**VILLAGE OF POMONA  
PLANNING BOARD MEETING**

The Chabad of the Heights project was last reviewed by the Planning Board at the May 14, 2026 meeting. The site plans have been revised in accordance with the previous review comments. Responses to the review letters and comments are provided in **bold** below.

PROJECT:  
**CHABAD OF THE HEIGHTS**  
34 NORTH RIDGE ROAD

SHEET TITLE:  
**GRADING AND UTILITY PLAN**

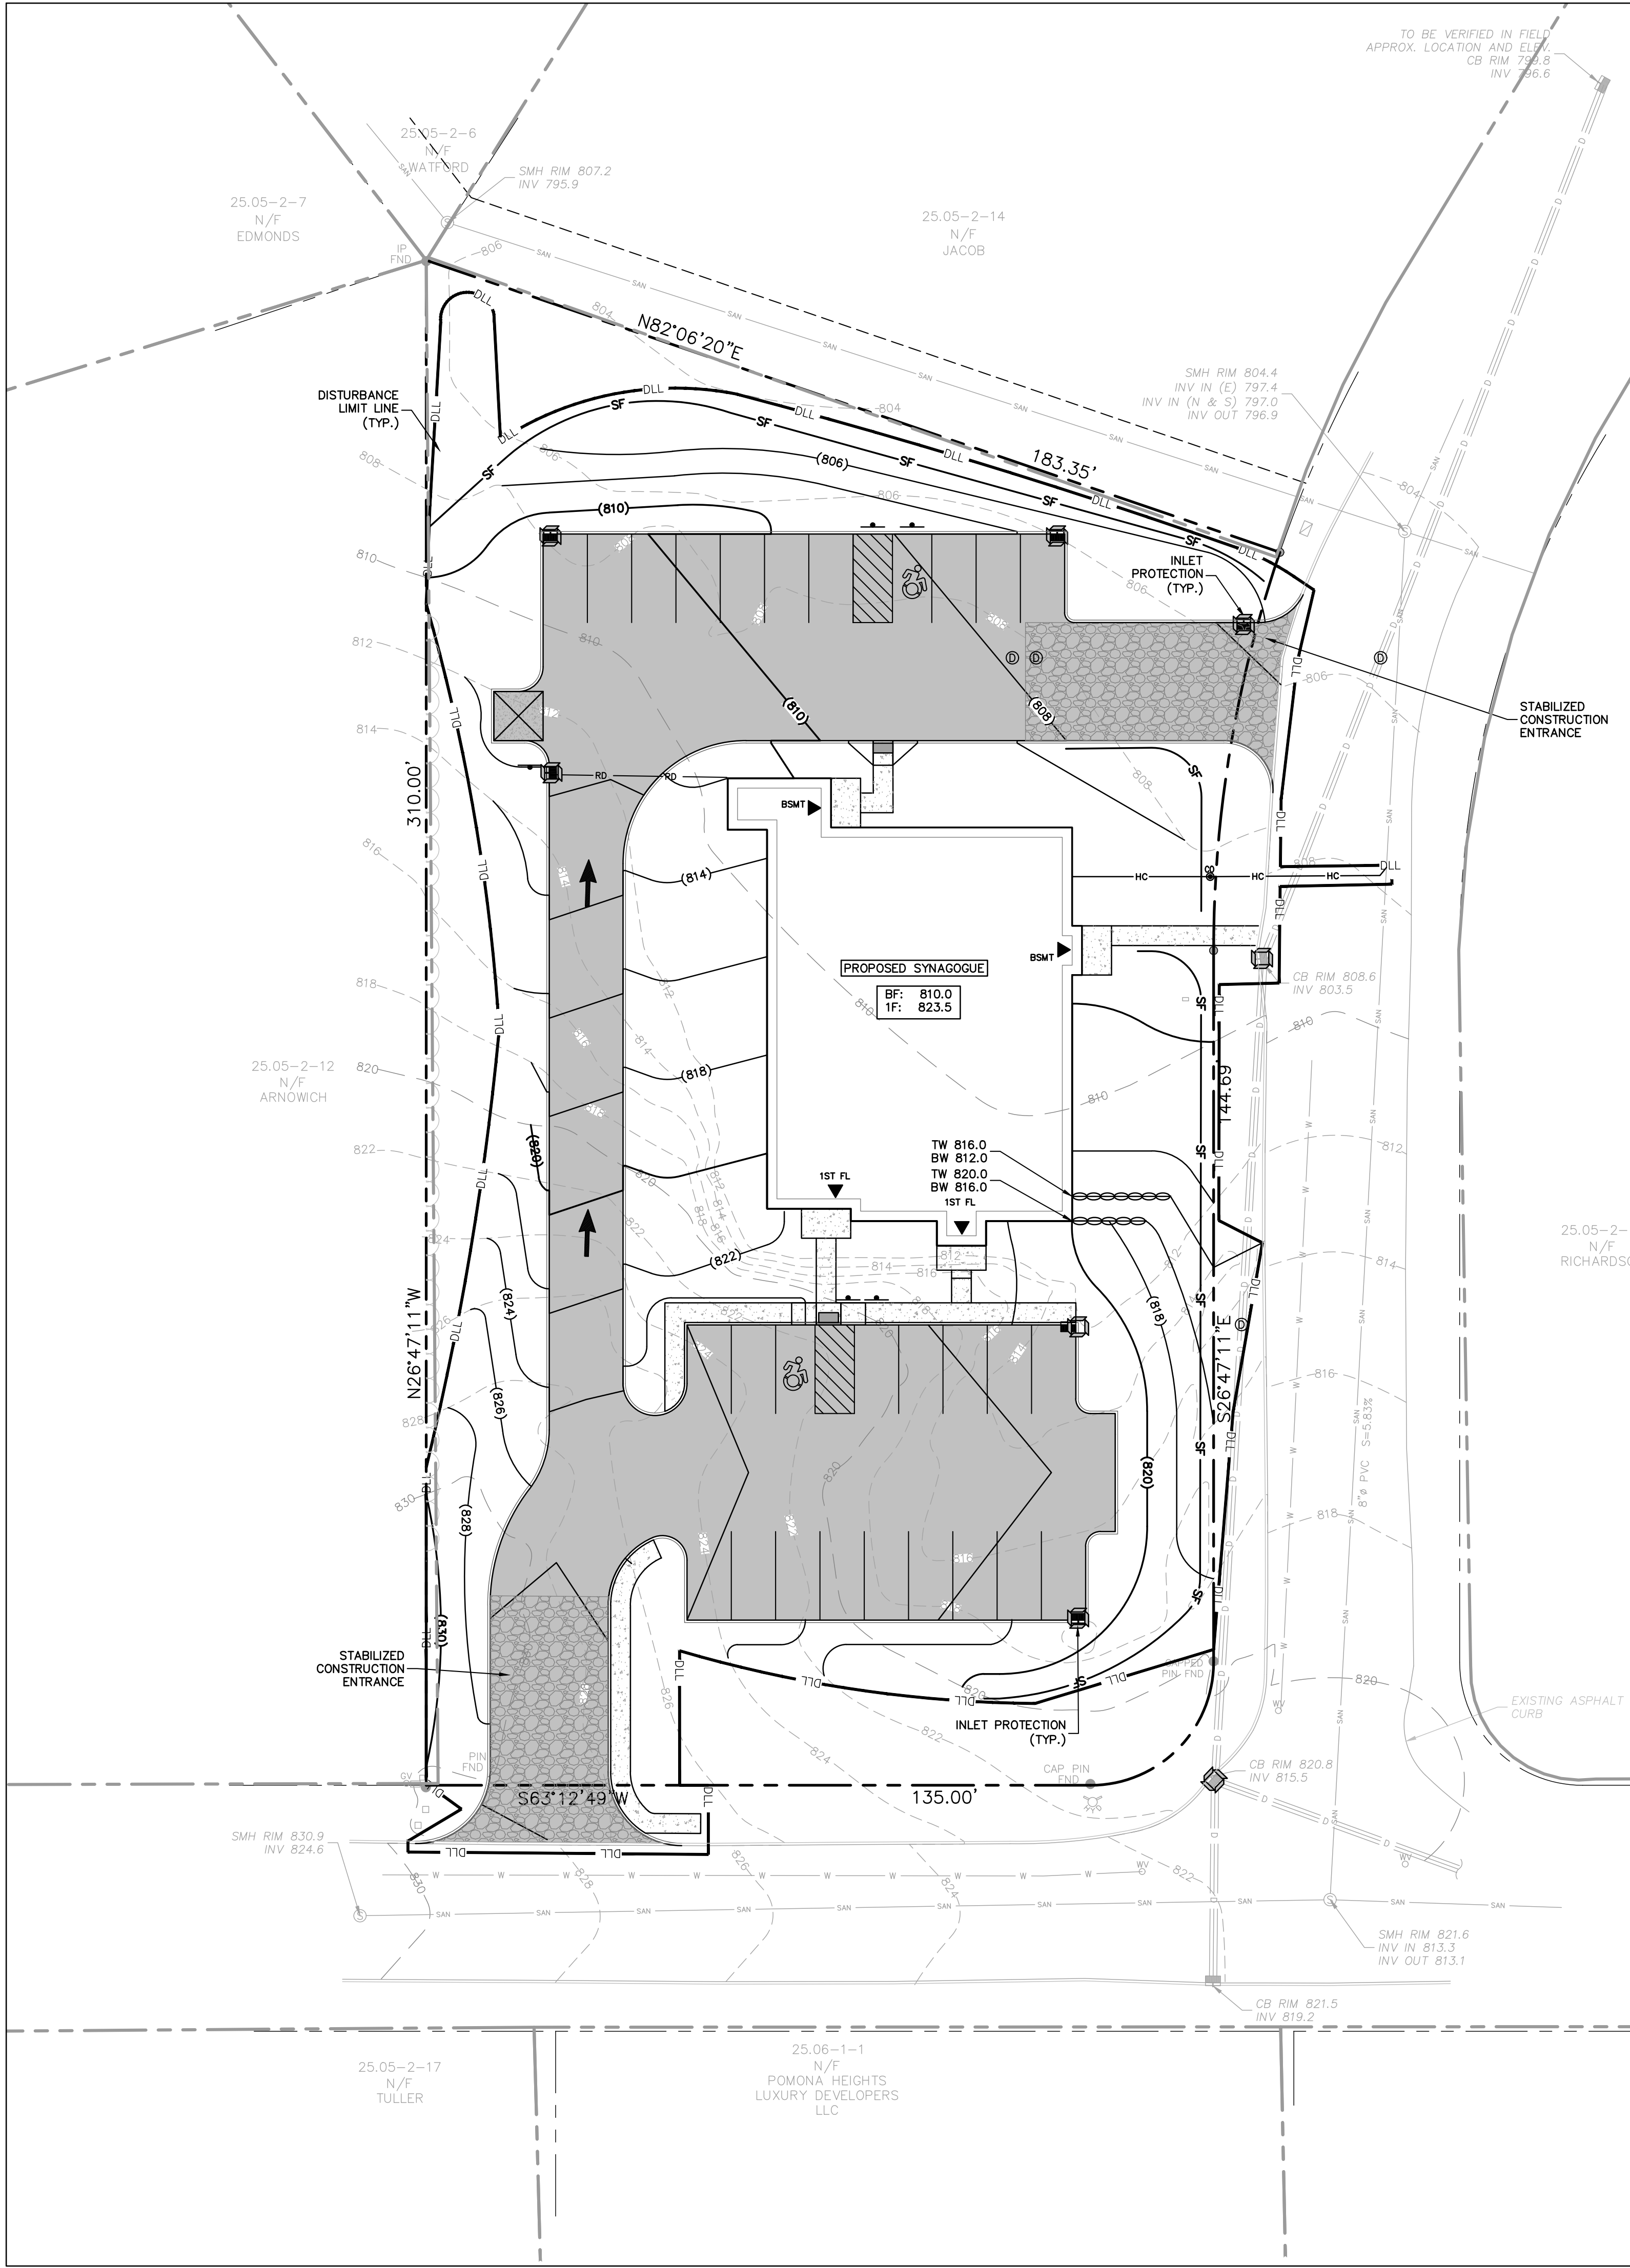
4. 9/2025 - It appears that the applicant will need to propose retaining walls or engineered slopes along the site boundaries to support the spot elevations shown on the “Overlook Road” parking area. The applicant should provide a grading plan and details of the retaining walls, including the appearance of the wall. 5/2026 – Comment remains.

**The grading plan has been revised. A retaining wall will not be necessary to support the parking lot on the southern side of the property.**

SHEET TITLE:  
**LANDSCAPING PLAN**

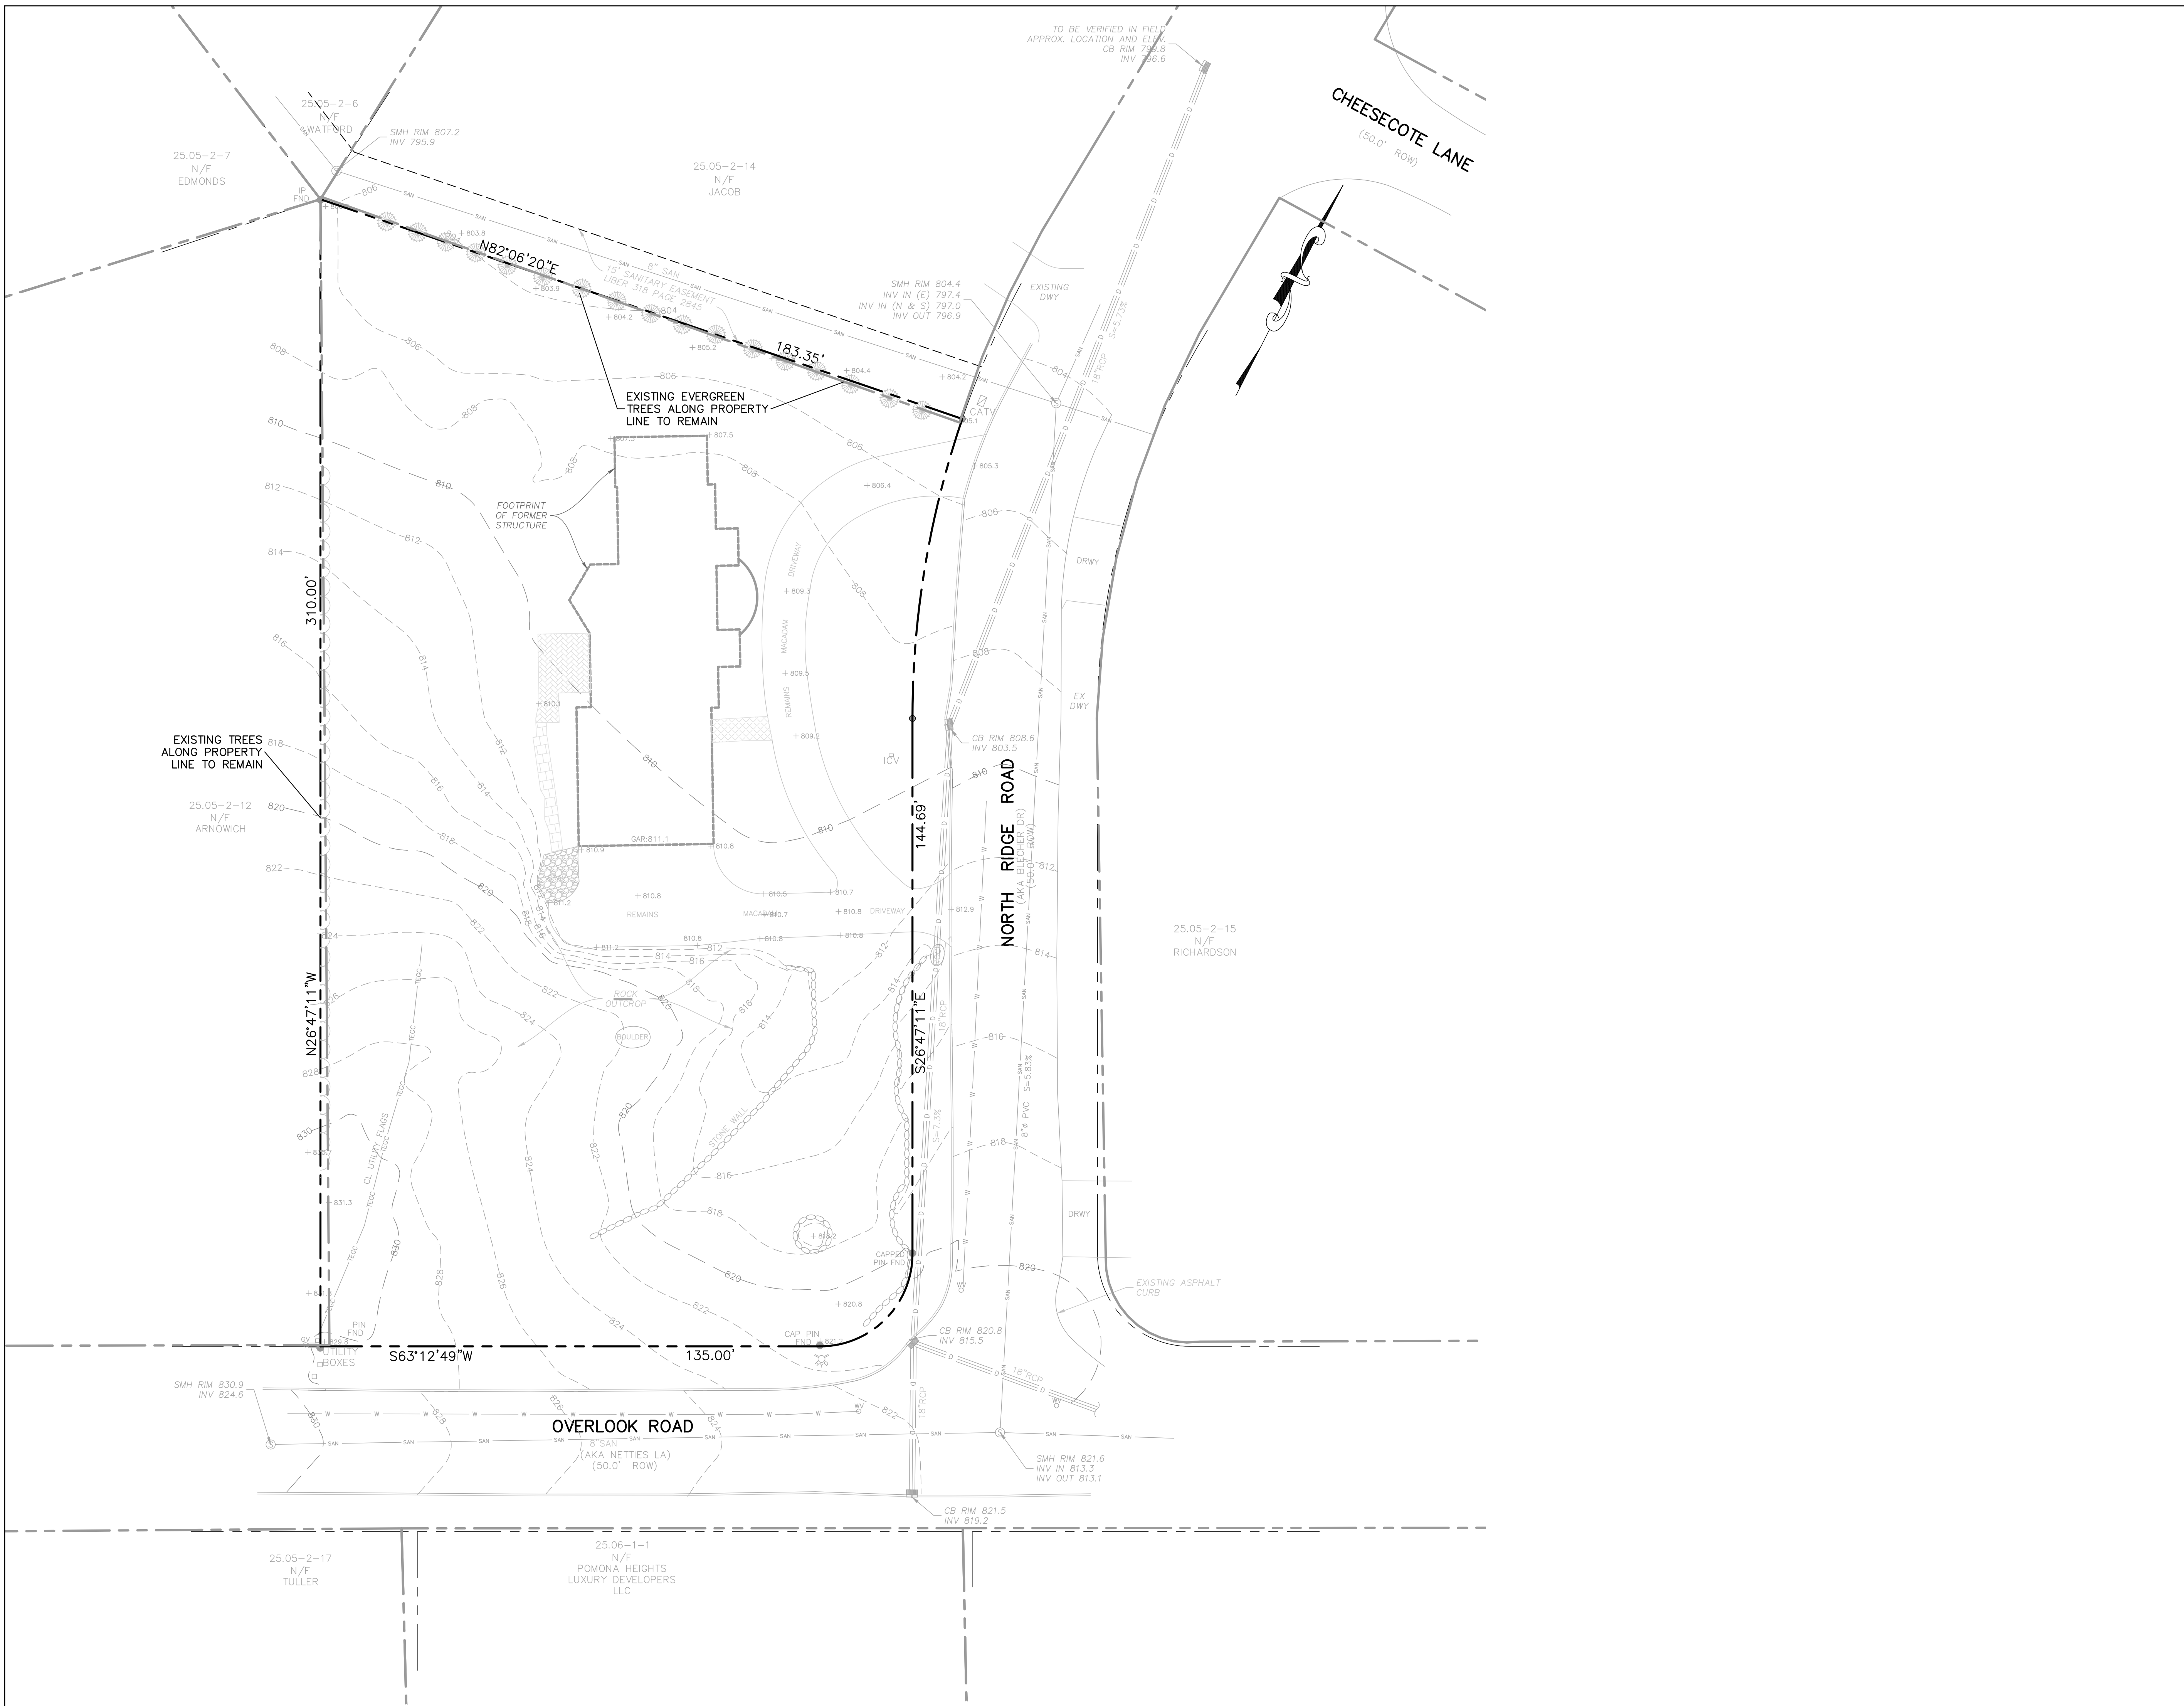
5/2026 – Lighting and Landscape plans were provided with the April 2026 submission, however the landscaping plan did not identify existing trees to remain. Please provide.

9. 4/2026 - The applicant should identify existing vegetation to remain. In most instances retaining existing mature vegetation will be more protective of neighbors than planting extensive and unnatural looking privacy screens. For example, if trees can be retained along the property boundary with n/f Arnovich, it may be better to install a privacy fence than to plant a double row of green giant thuja. The applicant may also wish to consider Ilex Glabra (inkberry holly) as a native NY alternative to boxwood that is resistant to boxwood blight and box tree moth. **5/2026** – Comment remains.

**Trees to remain have been identified on landscaping plan.**

**The additional landscaping has been provided in response to previous comments from the Planning Board and consultants. Existing trees along the westerly and northerly property lines are proposed to remain.**
